# Pennsylvania Power & Light Company

SUSQUEHANNA STEAM ELECTRIC STATION  
REQUEST FOR ADDITIONAL INFORMATION -  
FIRE PROTECTION REVIEW  
PLA-3192                      FILES R41-2/A17-15

Docket Nos. 50-387  
and 50-388

Figure 1: A Simplified Diagram of the Suppression Pool Cooling Flowpath for RHR Loop A.

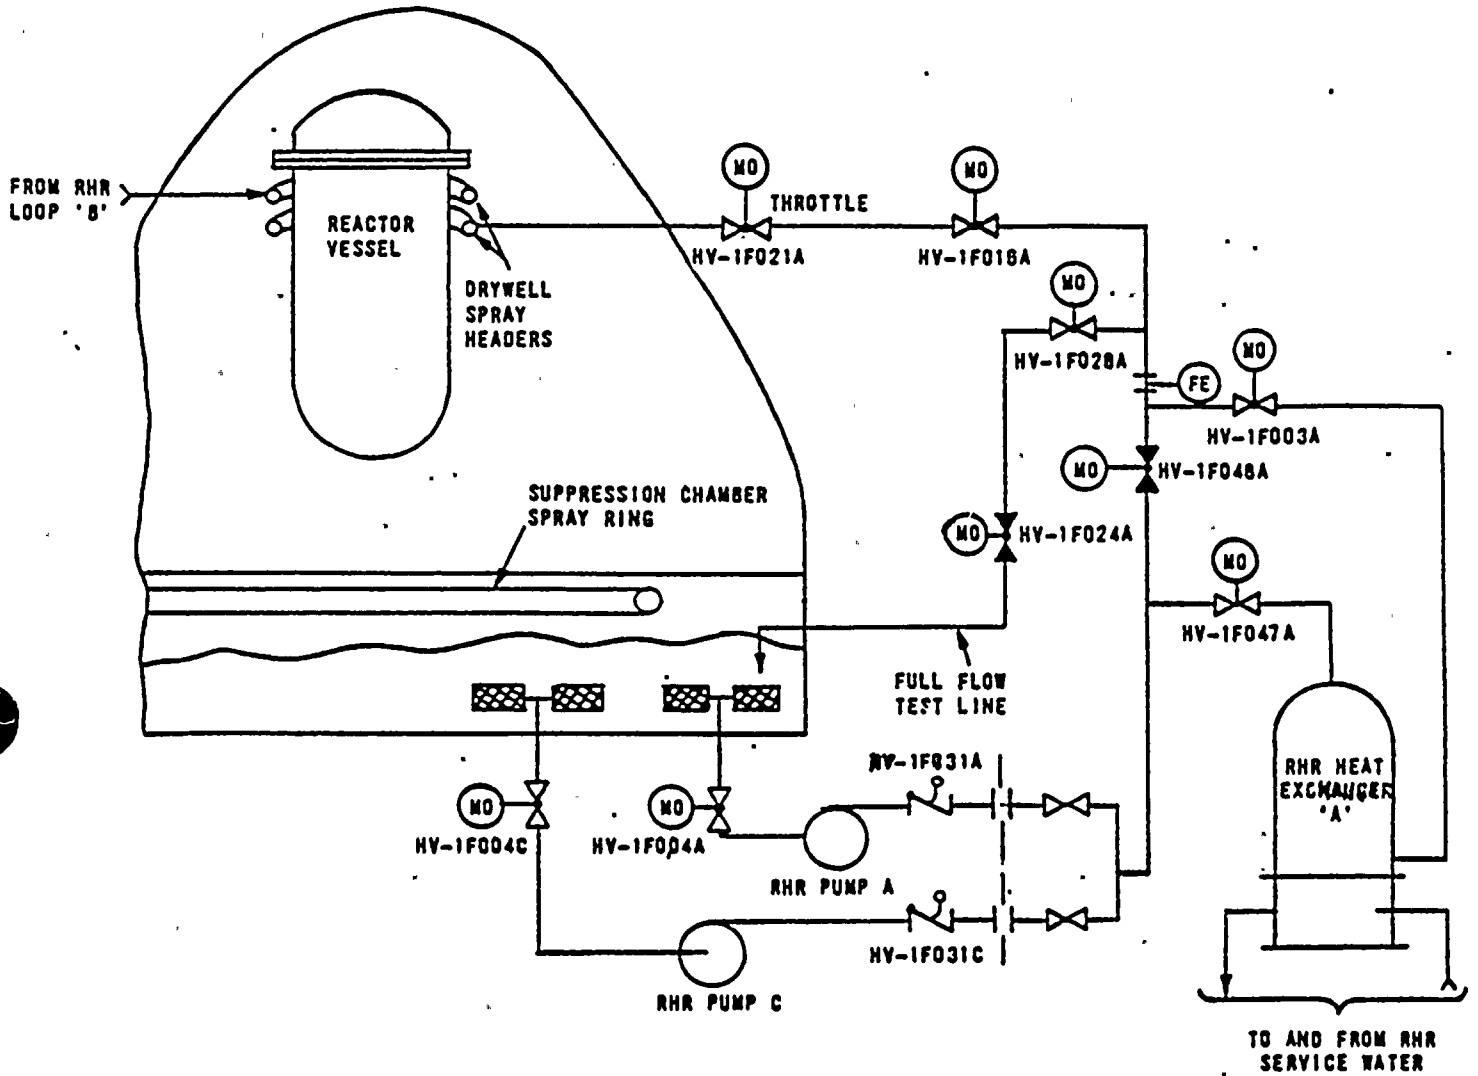
Staff guidance identifies that suppression pool temperature indication is part of the minimum monitoring capability for BWRs for achieving safe shutdown. Discussions provided in the request for deviation from this requirement submitted by the Licensee, do not adequately justify the lack of need for this indication nor that alternate means are available for the operators for ensuring that the suppression pool temperature is being maintained within the allowable range. In addition, procedure EO-100-009 "Plant Shutdown From Outside Control Room" does not adequately address the possibility of loss of temperature indication and subsequent alternate means of monitoring temperature.

Provide additional justification for the lack of suppression pool temperature indication and provide a proposed revision to procedure EO-100-009 which adequately addresses this possibility. The justification should include a discussion of how stable hot shutdown can be achieved and monitored with no temperature indication and what indicators would be used to ensure that a stable condition is maintained. Further, the justification should identify the indication used to achieve and monitor cold shutdown within 72 hours.

Before discussing the governing emergency procedures, a short description of the function of the SPOTMOS indication system, the suppression pool, the RHR heat exchanger and the spray pond as utilized in the suppression pool cooling mode is provided. Please refer to Figure 1, a simplified diagram of the suppression pool cooling flowpath for RHR Loop A.

The suppression pool cooling path utilizes a RHR pump which takes a suction from the suppression pool through the F004 valve, enters the RHR heat exchanger through the F047 valve, flows through the Hx shell and

exits through the F003 valve. The flow path continues through the F028 valve and through the F024 valve back to the suppression pool.

The RHRSW system takes a suction from the spray pond, then enters the RHR heat exchanger, flows through the heat exchanger tubes and exits and returns to the spray pond through the spray network risers.
